STATE OF VERMONT
AGENCY OF TRANSPORTATION

PROPOSED IMPROVEMENT
BRIDGE PROJECT
TOWN OF GUILFORD
COUNTY OF WINDHAM

ROUTE: T.H. 10, CLASS III (LOCAL ROAD), BRIDGE NO. 65

RECORD PLANS

TYPICAL BRIDGE SECTION
SCALE 1/2" = 1'-0"

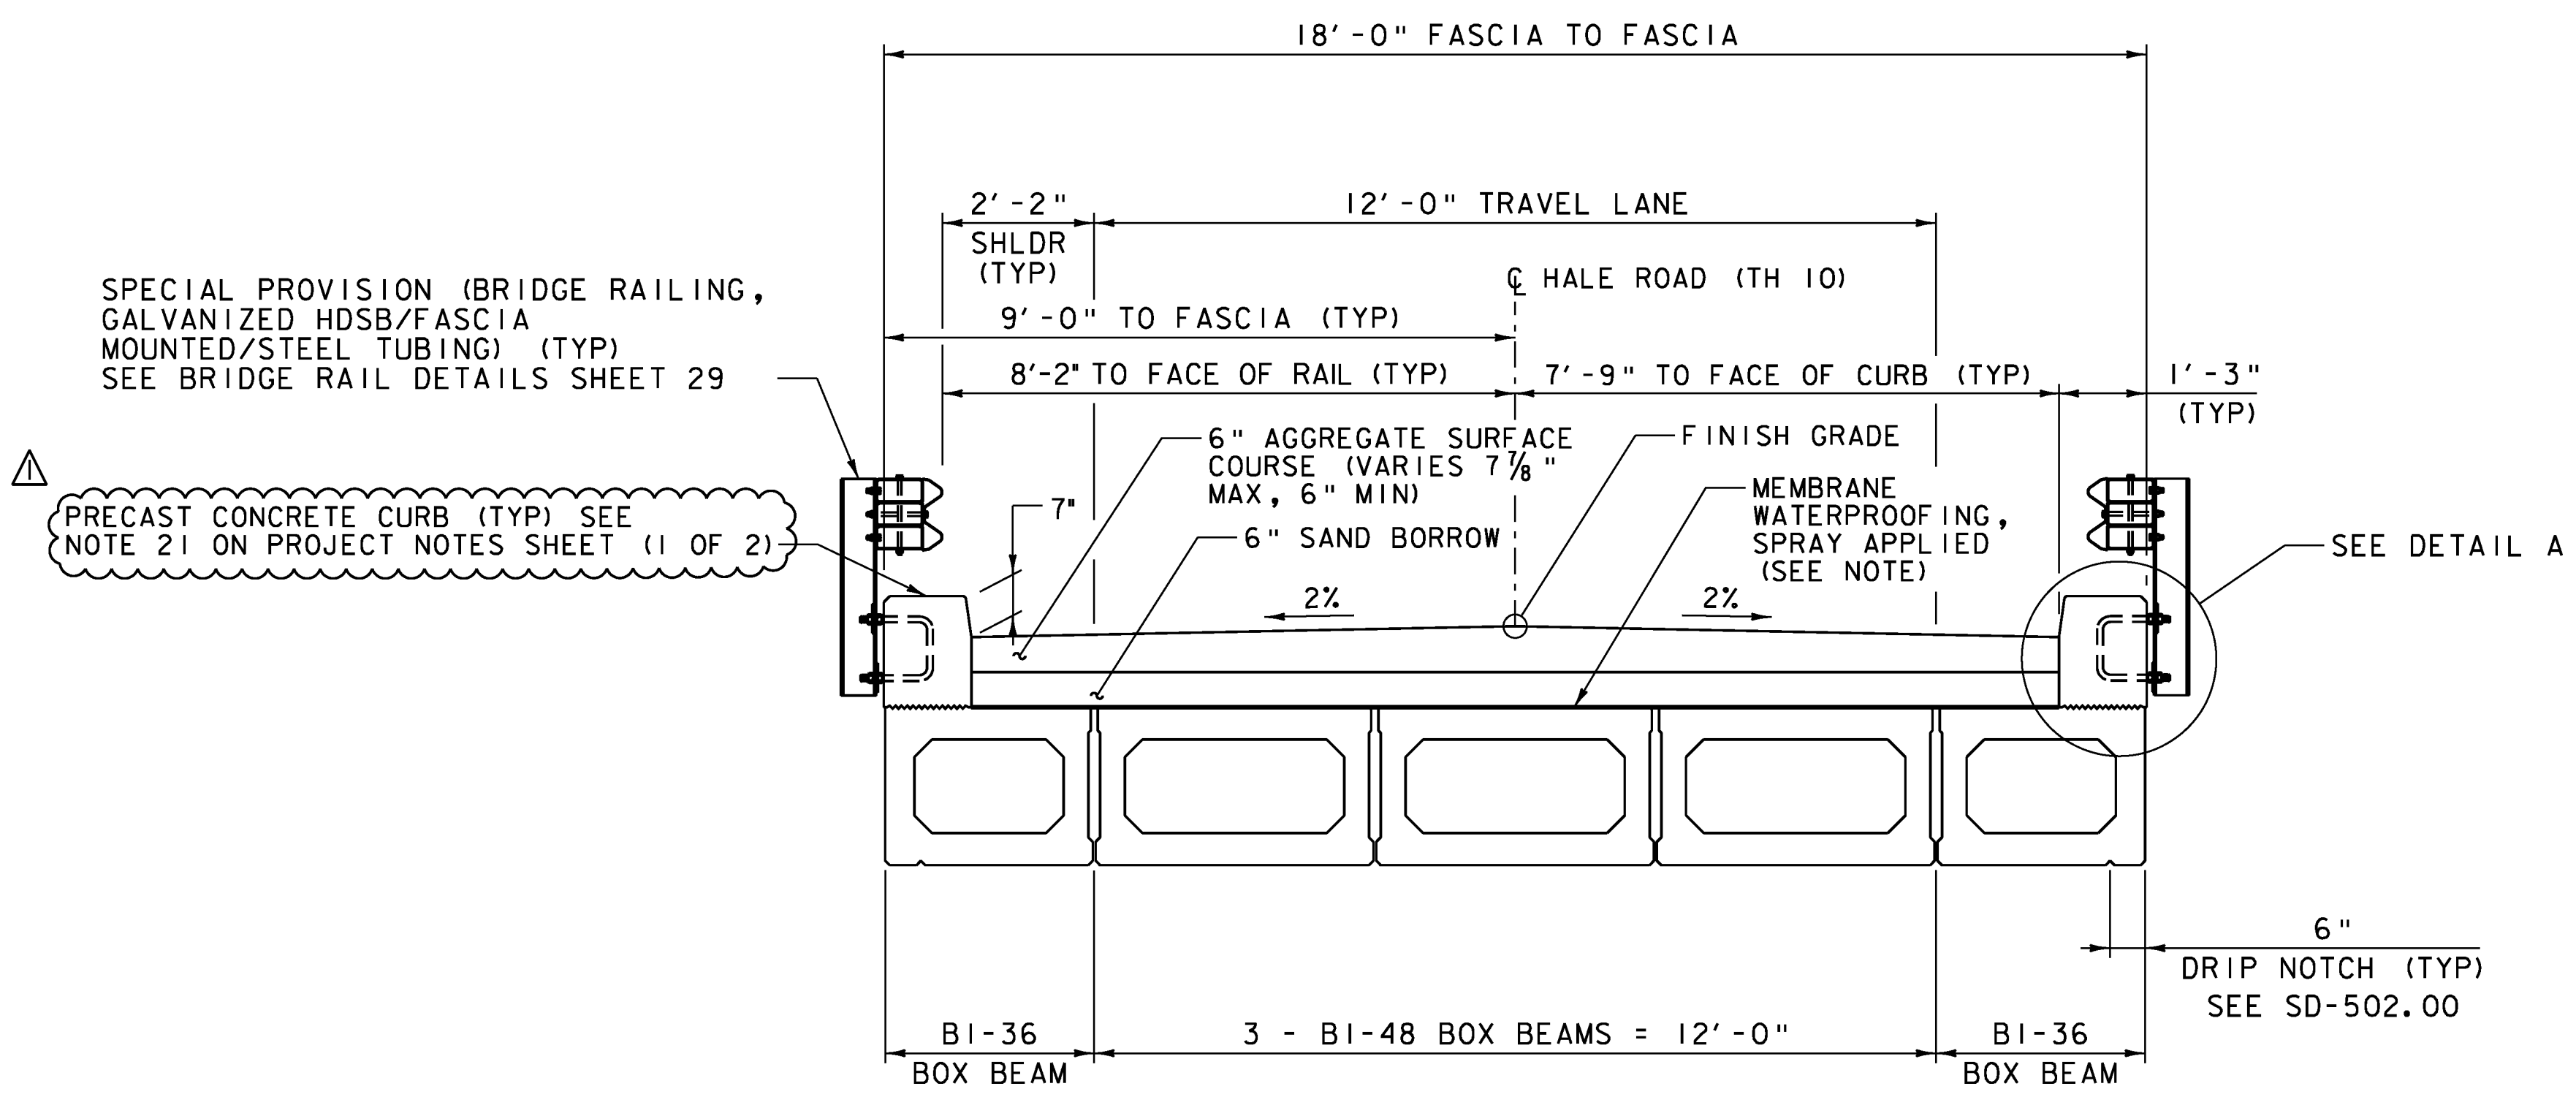
REVISION	DESCRIPTION	DATE
△	PRECAST CONCRETE CURB	12/3/2013
PROJECT NAME: GUILFORD		
PROJECT NUMBER: BRO 1442(36)		
FILE NAME: z10j064typ.dgn		PLOT DATE: 12/3/2013
PROJECT LEADER: S.E. BURBANK		DRAWN BY: E.A. FIALA
DESIGNED BY: E.A. FIALA		CHECKED BY: S.E. BURBANK
TYPICAL BRIDGE SECTION		SHEET 3 OF 42

**GENERAL NOTES**

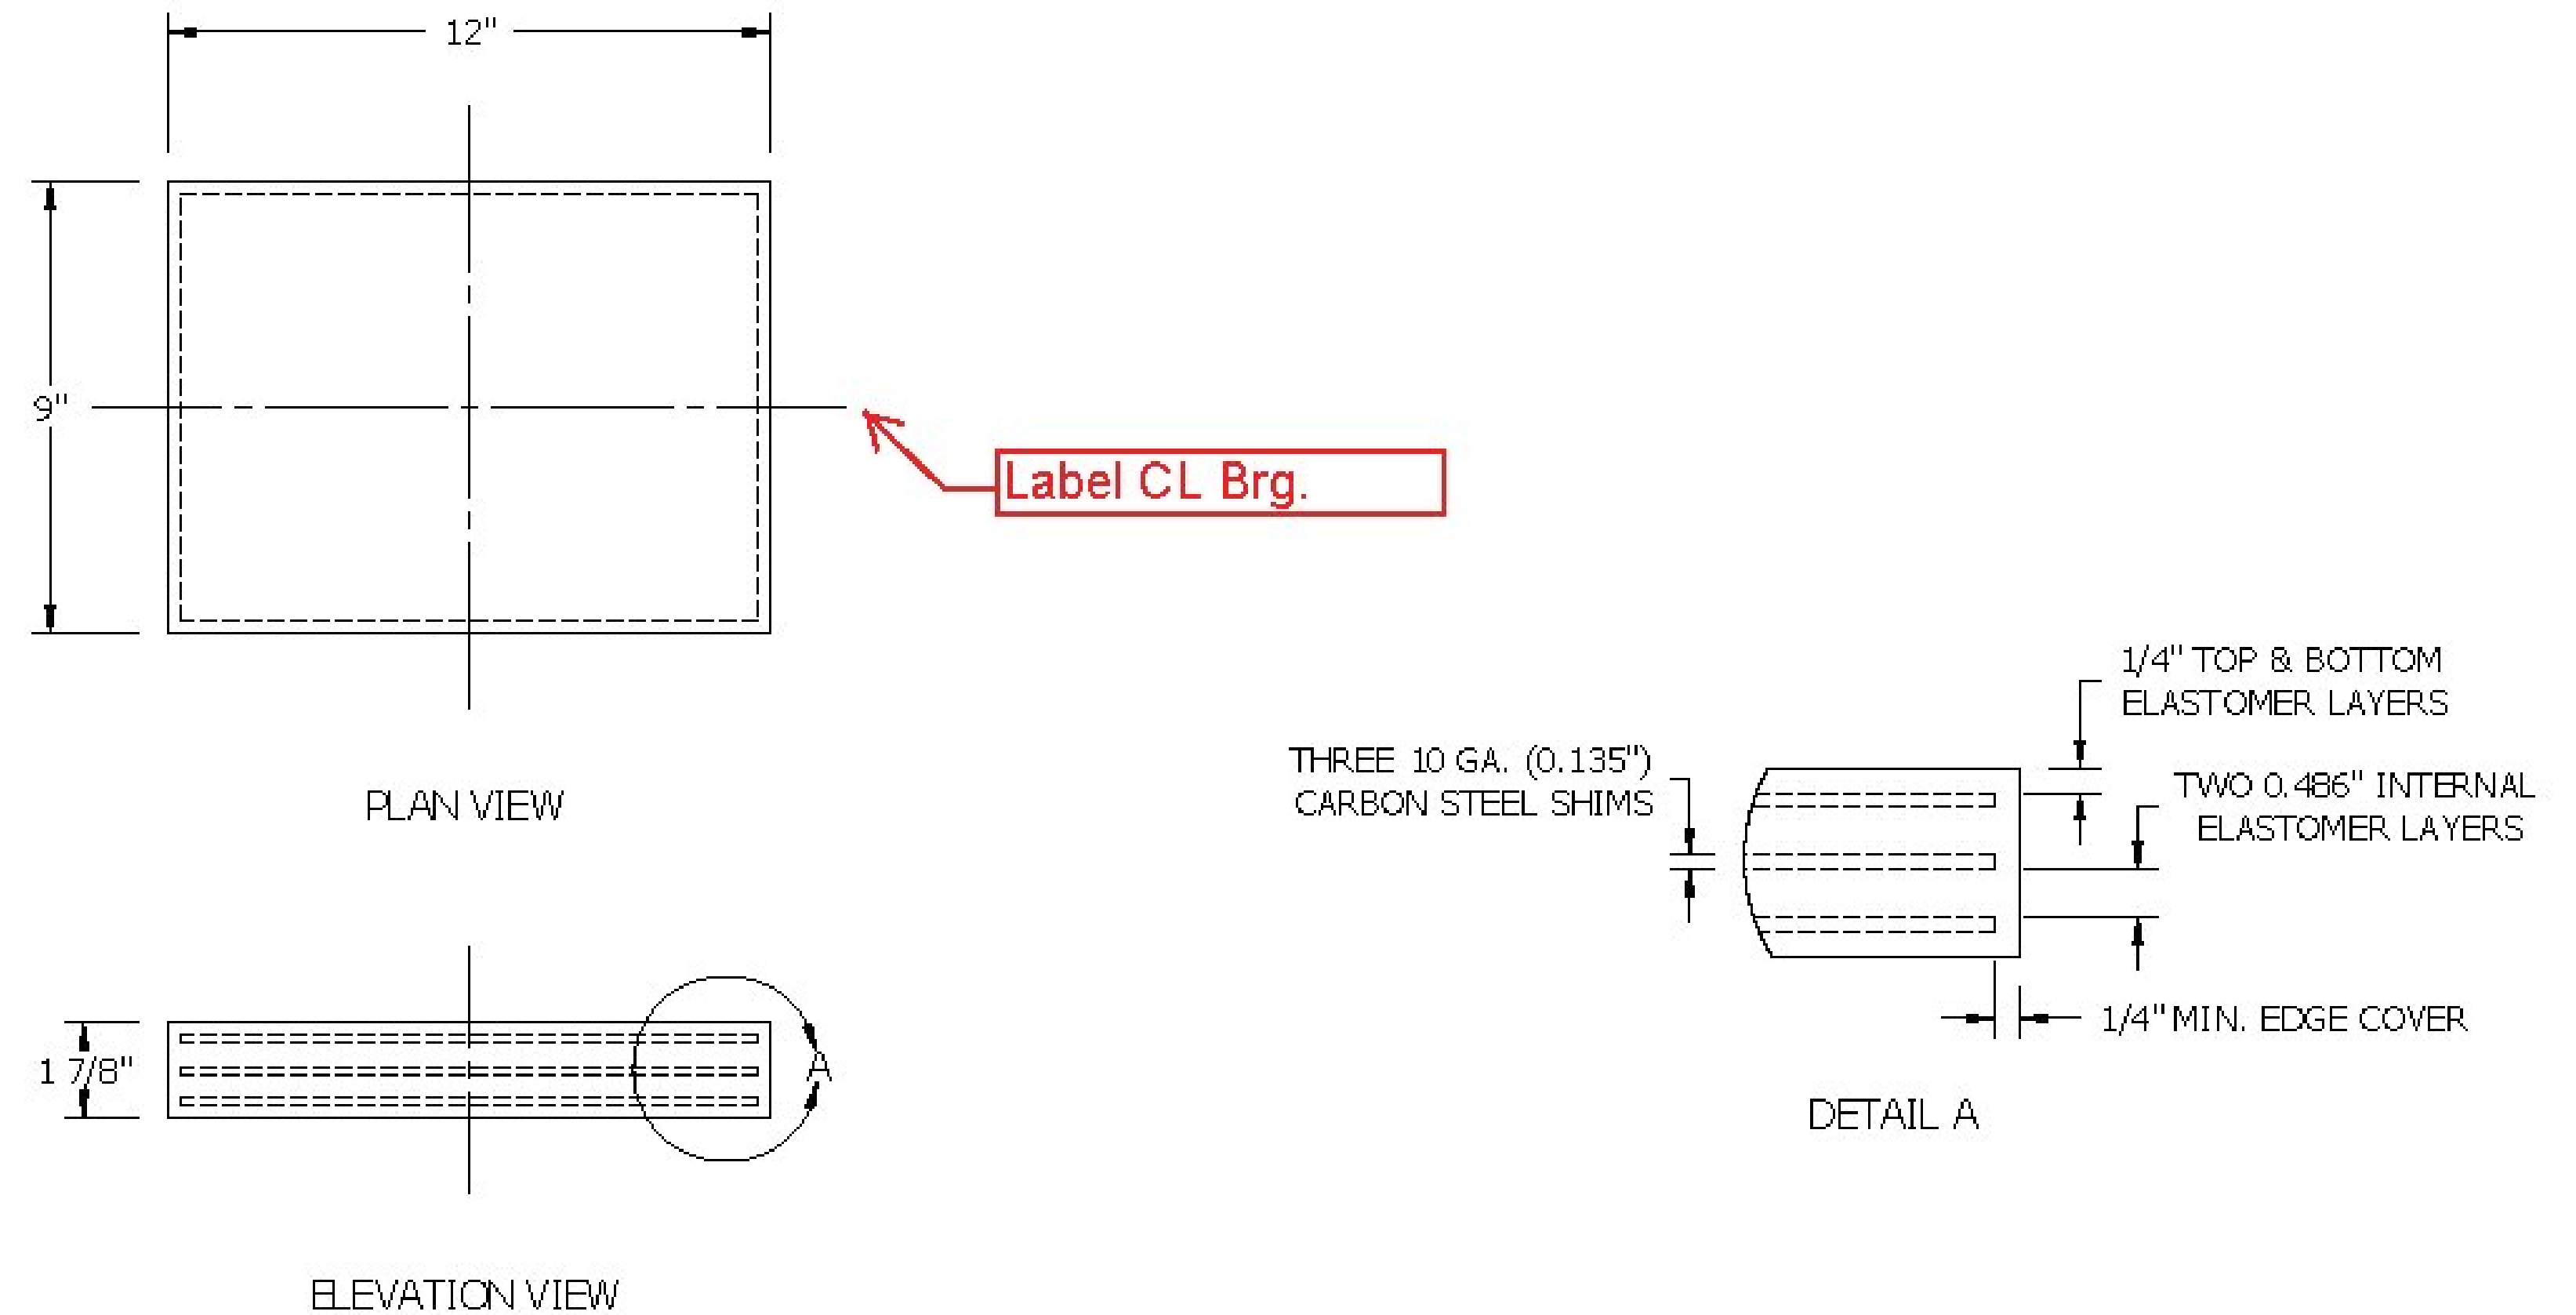
CARBON STEEL SHIMS.....ASTM A 1011, GR. 40  
 (10 GA. IN LIEU OF 1/8" DUE TO AVAILABILITY)
- TOLERANCES:**  
**LAMINATED PADS:**  
 VERTICAL.....-0, +1/4"  
 HORIZONTAL.....-0, +1/4"  
 THICKNESS OF LAYERS.....±1/8"  
 PARALLELISM TOP.....0.005 rad  
 PARALLELISM SIDES.....1/4"  
 EDGE COVER.....-0, +1/8"
- MARKINGS:**  
 EACH BEARING SHALL BE PERMANENTLY MARKED IN A LOCATION THAT IS VISIBLE WHEN THE DEVICE IS INSTALLED IN THE COMPLETED STRUCTURE. MARKING SHALL BE SEP STANDARD:  
 CONTRACT/ORDER #  
 LOT#  
 BEARING ID # (MK. #)  
 LOCATION/BRIDGE #  
 ELASTOMER TYPE AND GRADE  
 ORIENTATION (WHERE APPLICABLE)
- TESTING:** IN ACCORDANCE WITH THE VERMONT AOT SPECIFICATIONS. DESIGN METHOD A
- REPRESENTATIVE**  
 CUSTOMER SERVICE: STEVE BOWMAN.....903-677-4318  
 TECHNICAL: MIKE SPELLMAN.....903-677-4342

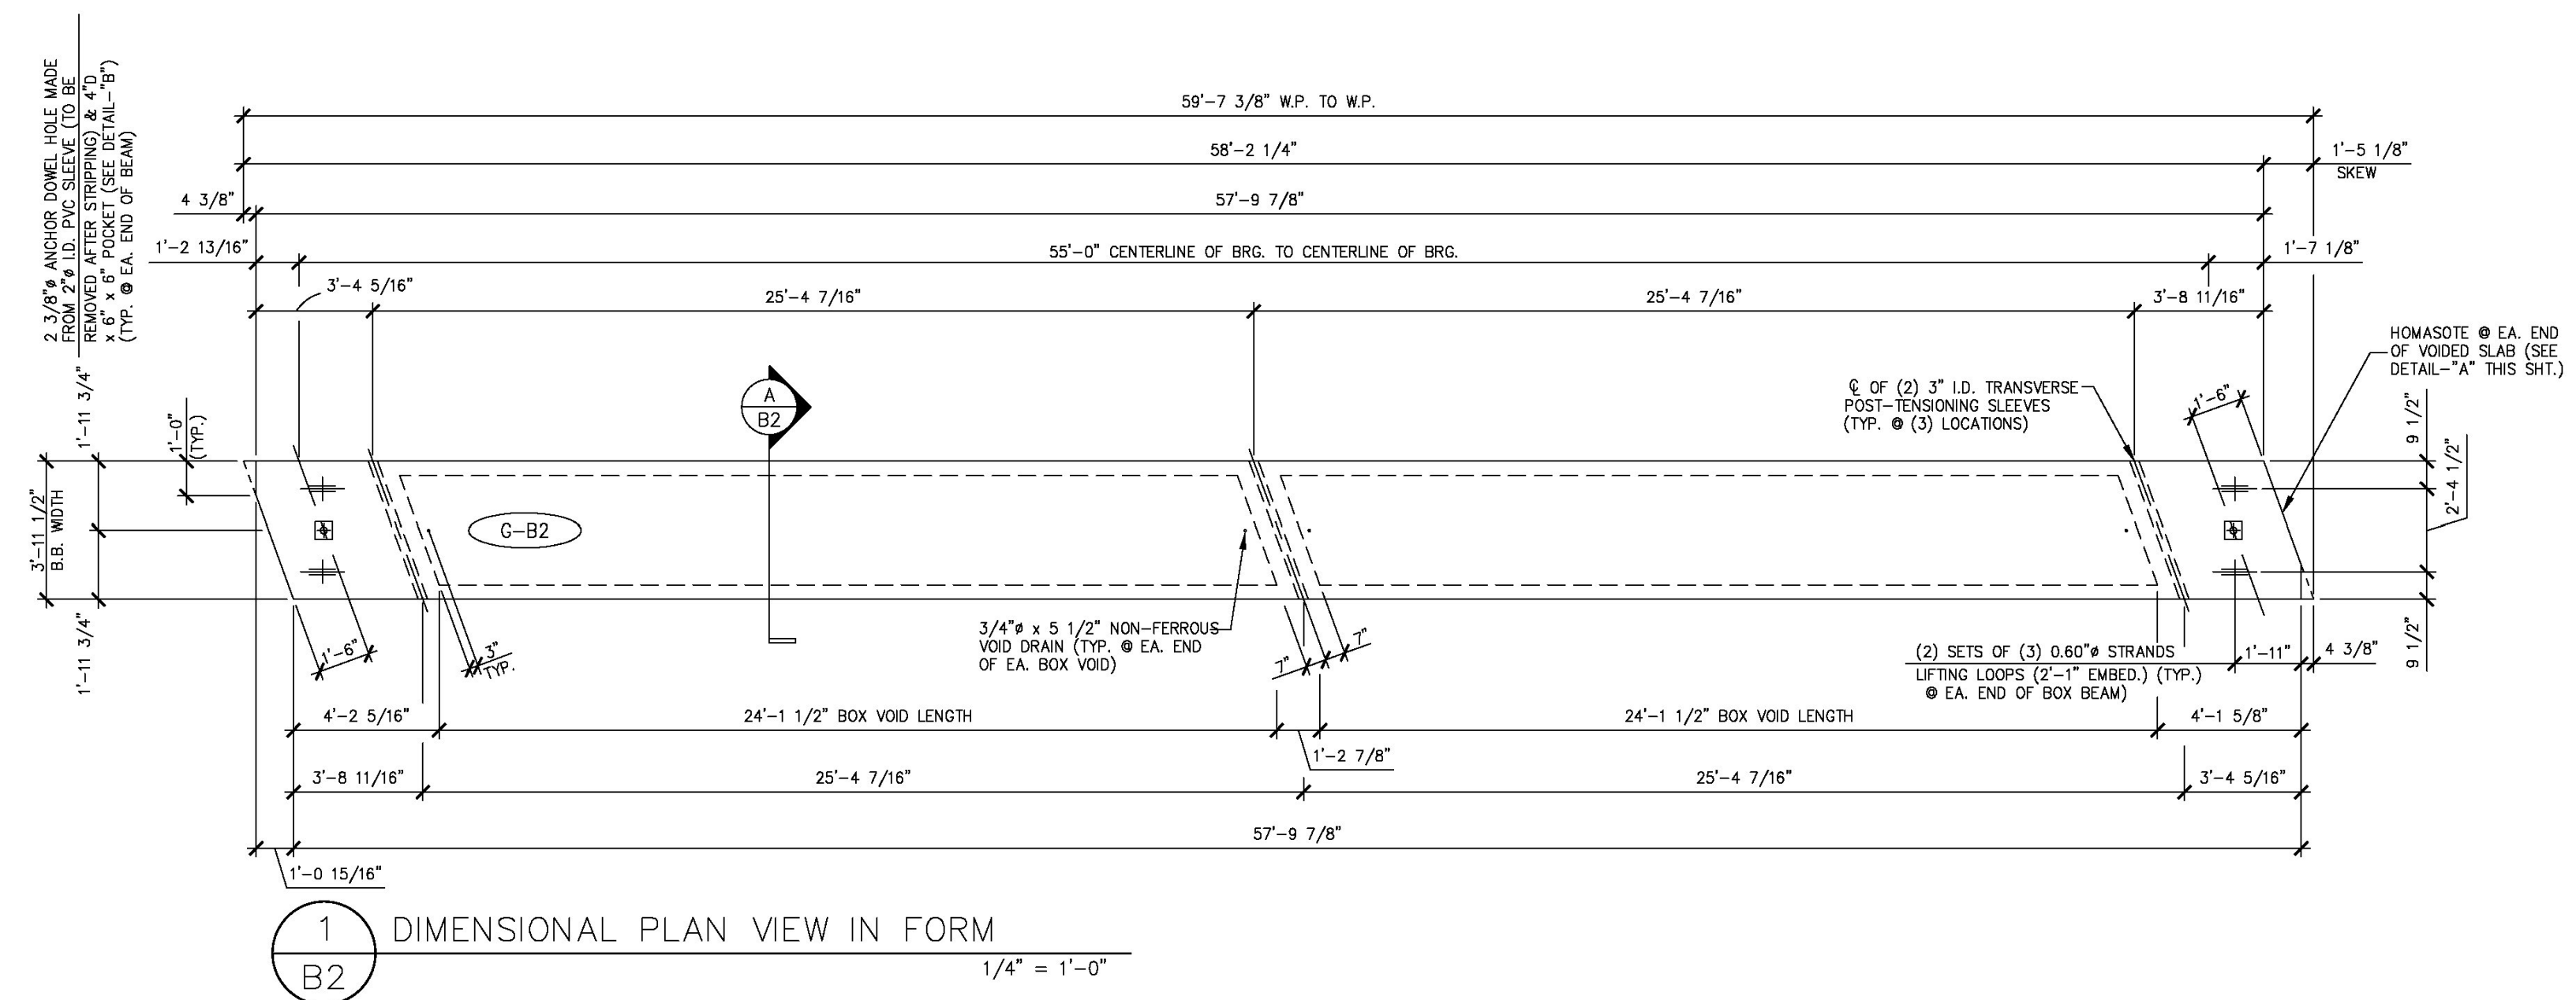
4-7-14 REVISED AS NOTED
